The Clean Energy Council (CEC) welcomes the opportunity to provide feedback on CSIRO and AEMO's GenCost 2019-20 preliminary results.

Our suggestions on generation cost model inputs and assumptions on wind, solar and energy storage

Figure 1: The Power Purchase Agreement (PPA) published results from the ACT tender rounds and estimated levels for Snowy Hydro and another site in Australia².

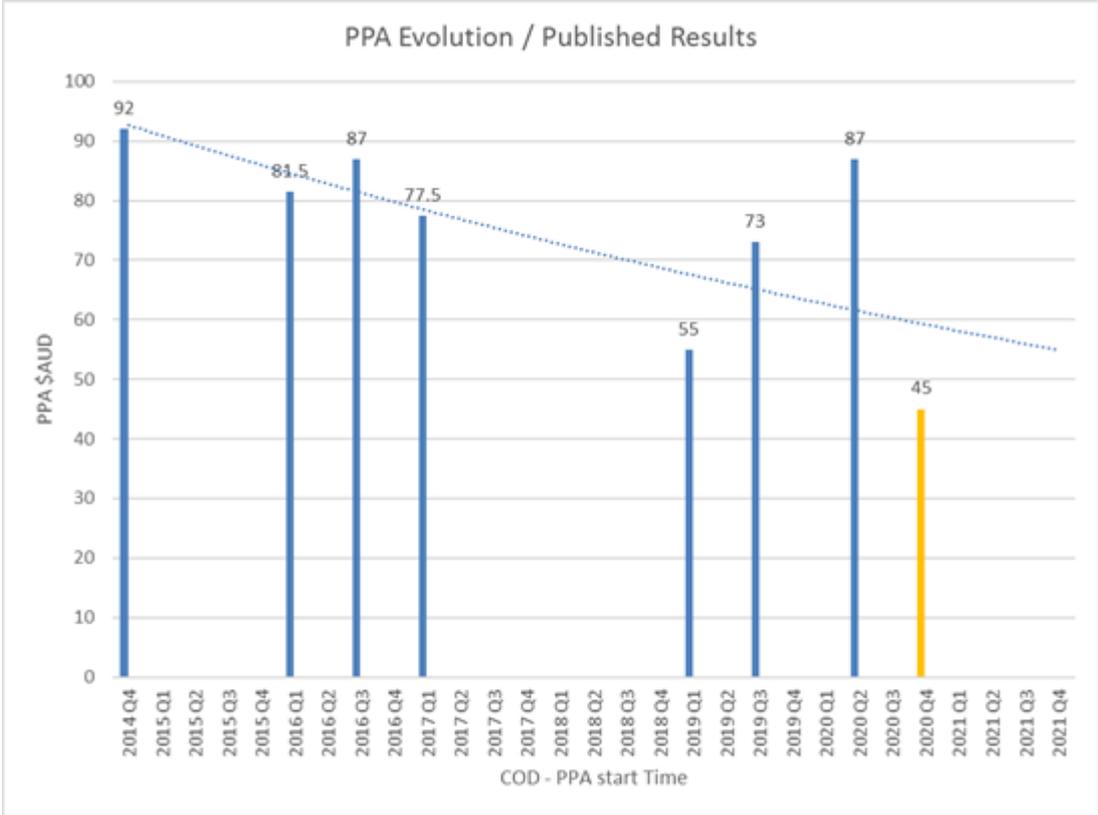
The same original equipment manufacturer of wind and solar has graphed Power Purchase Agreement (PPA) results for wind projects that have been published, results from the ACT tender rounds (shown in blue in figure 1) and estimated level and the Snowy Hydro and another site in Australia, which is shown at \$45 level (shown in orange in figure 1). They recommend the minimum level already achieved in 2020, should be reduced to \$45, as wind is already below the \$52 indicated by the report. This is 10

years earlier than previously nominated in the report, therefore subsequent years for 2030, 2040 and 2050 would also see reductions based on the learning rate¹.
